The Town of Hilton Head Island
Design Review Board Regular Meeting
Tuesday, March 10, 2020 – 1:15 p.m.
Benjamin M. Racusin Council Chambers
AGENDA

Town of Hilton Head Island
Design Review Board

MEETING MINUTES

A6 LOUVERED AWNING DETAIL
1/2" = 1'-0"

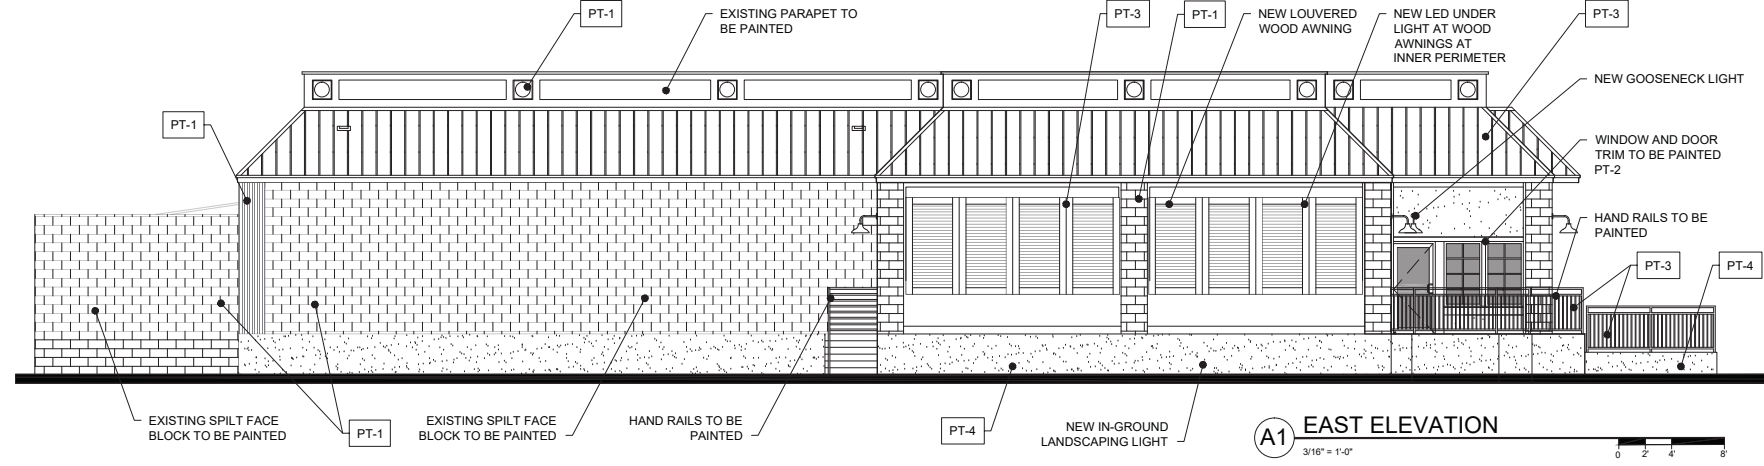
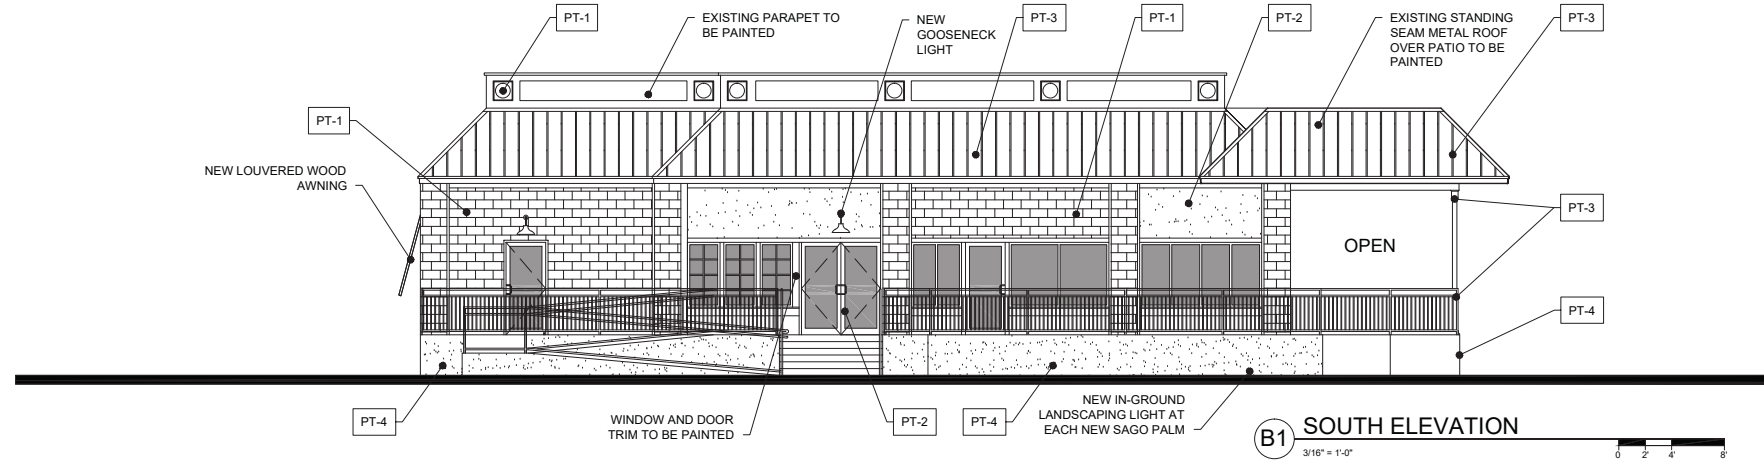
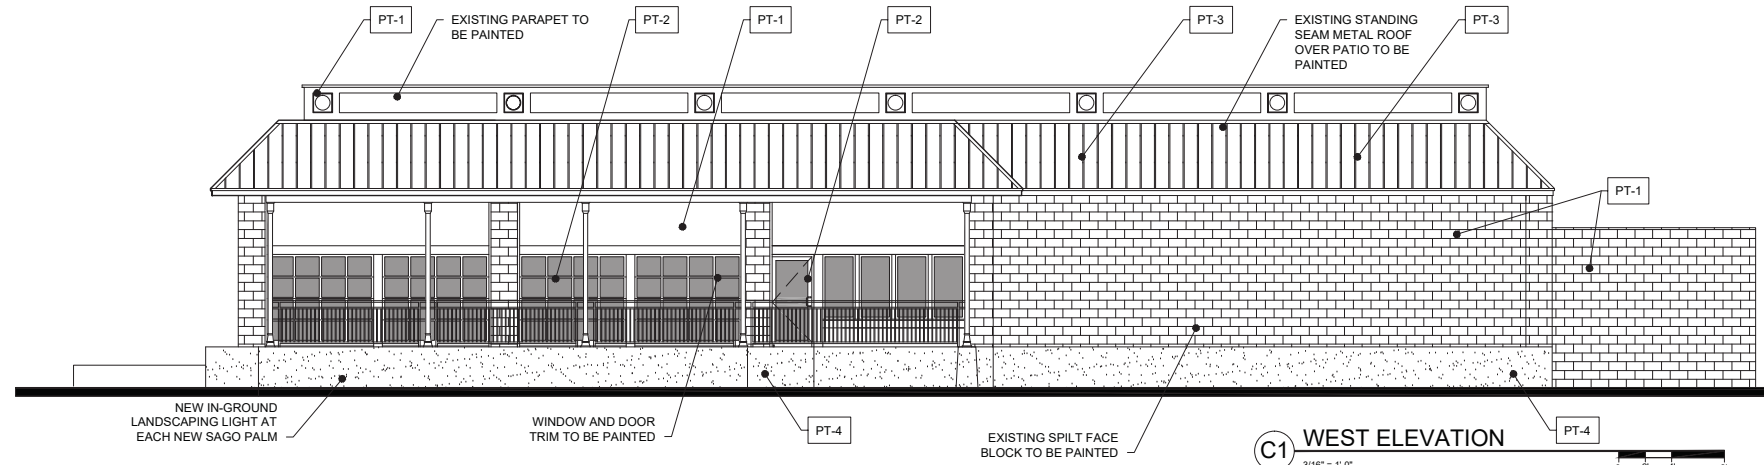
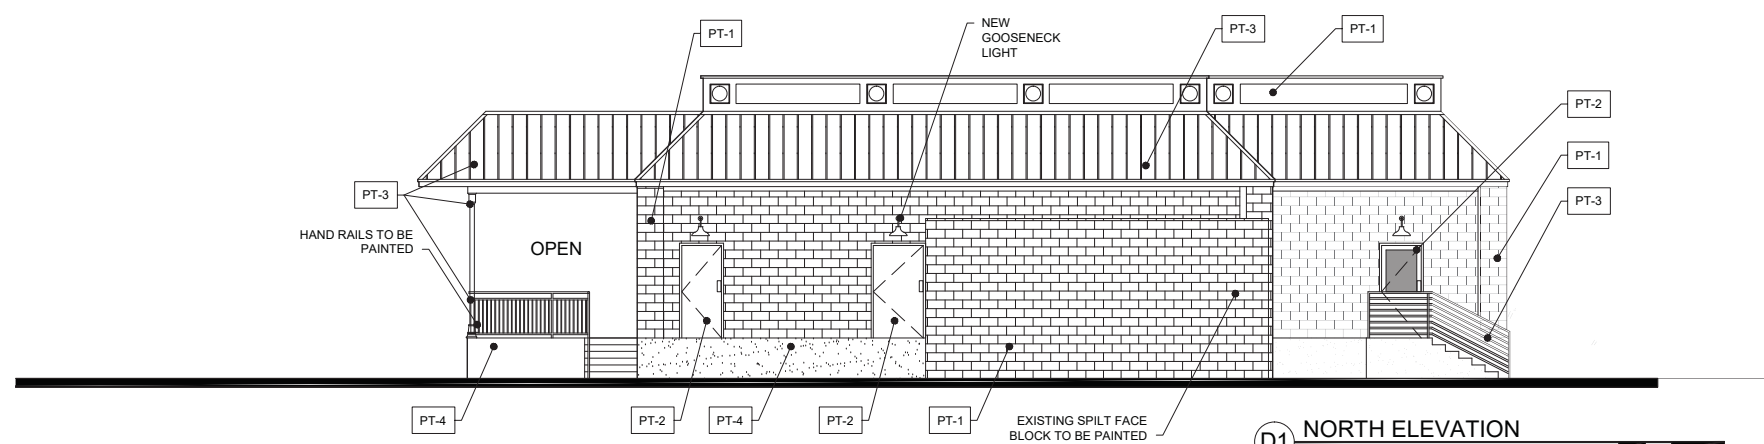
DESIGN GUIDE/LMO CRITERIA	Complies Yes	No	Not Applicable	Comments or Conditions
Utilizes a variety of materials, textures and colors	<input type="checkbox"/>	<input checked="" type="checkbox"/>	<input type="checkbox"/>	Staff suggest a third color (shade darker) be used on the cmu (SW 9084 Cocoa Whip or SW 6074 Spalding Gray). It would serve to highlight the architectural detail / building materials and give interest to the building. The suggestion was to change the proposed color of the split face CMU to a slightly darker color.
Decorative lighting is limited and low wattage and adds to the visual character	<input type="checkbox"/>	<input checked="" type="checkbox"/>	<input type="checkbox"/>	Please clarify the under-light at the wood awnings. The additional cut sheets do not identify a specification that limits the lighting to 3000K or less.
Accessory elements are design to coordinate with the primary structure	<input type="checkbox"/>	<input checked="" type="checkbox"/>	<input type="checkbox"/>	Please provide a detail of the wood awnings.

- A fourth color SW6074, as suggested will be used at the base of the building to accent the building elements individually.
- A wood awning detail has been included on sheet A-201. The awnings shall protrude less than 3'-0" from the building wall and will not extend into the sidewalk area.

1 BEDROOM BUILDING

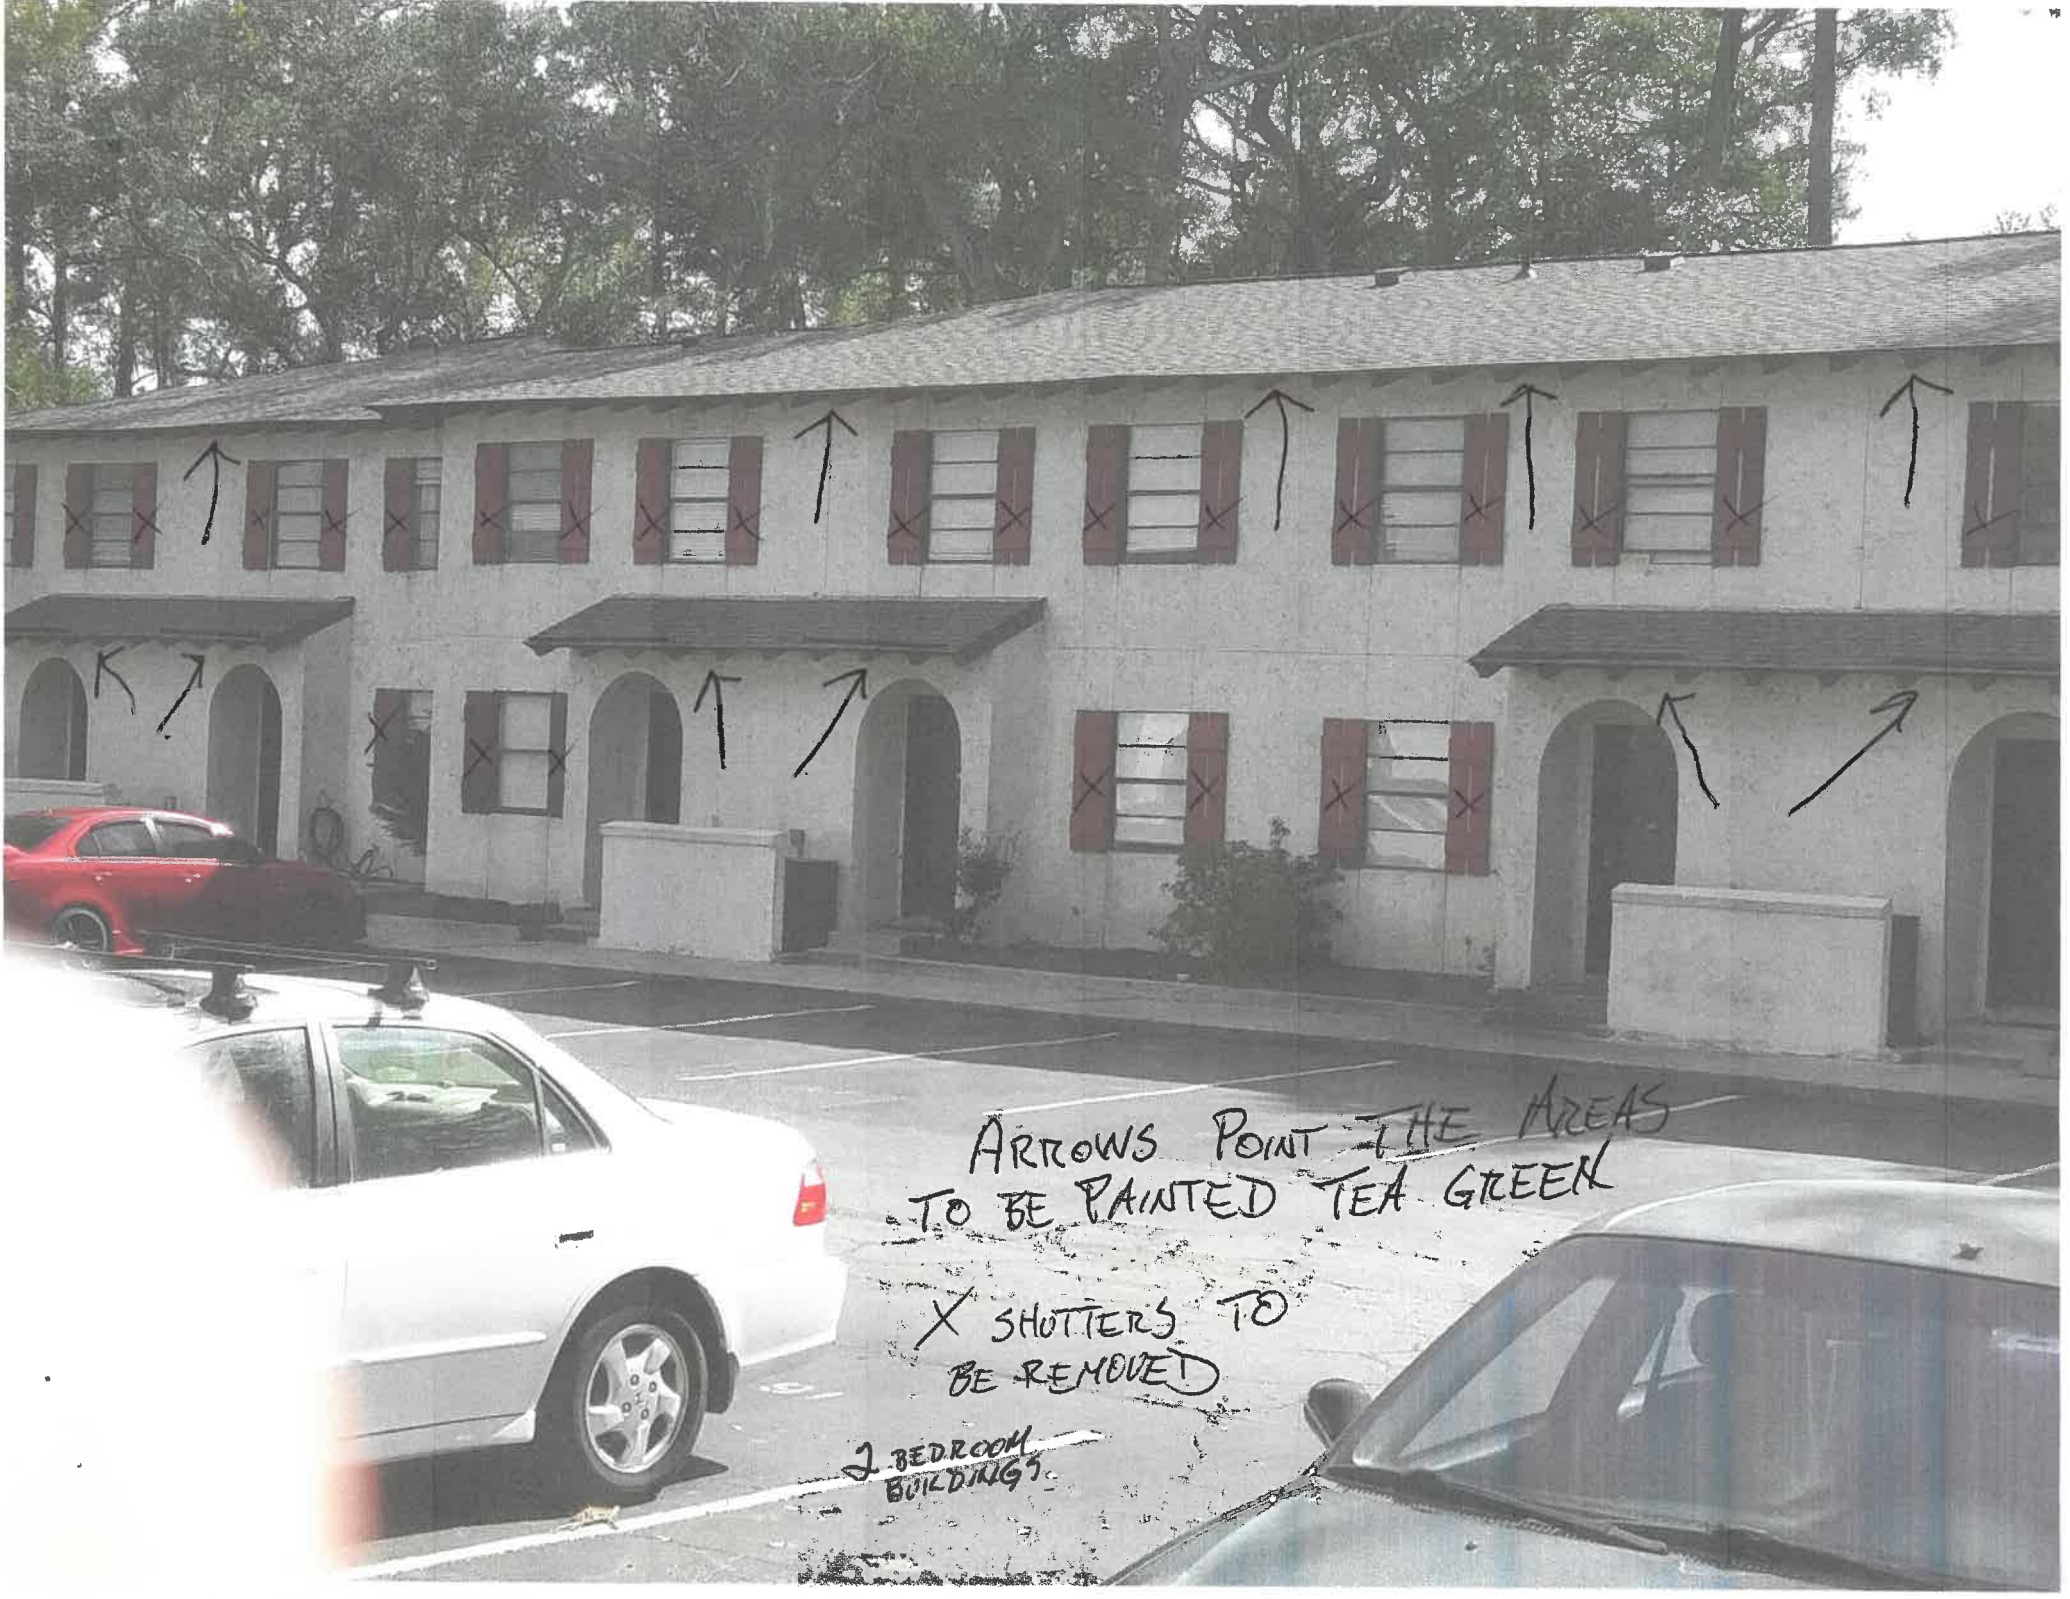
If I could offer a suggestion not a requirement... make rafters, etc SW 7032 Warm Stone and the doors SW 7034 Status Bronze. They are on either side of Brainstorm Bronze in the color deck.

MISC COMMENTS/QUESTIONS
To clarify the narrative, SW 6159 High Tea is the proposed trim color and SW 7033 Brainstorm Bronze is the proposed door color. These proposed colors do not scan well but physical color samples are available at Town Hall if you would like to view them.

↑ - AREAS TO BE PAINTED TEA GREEN
X - SHUTTERS TO BE REMOVED

○ - DOORS TO BE PAINTED BEAMSTORM BRONZE
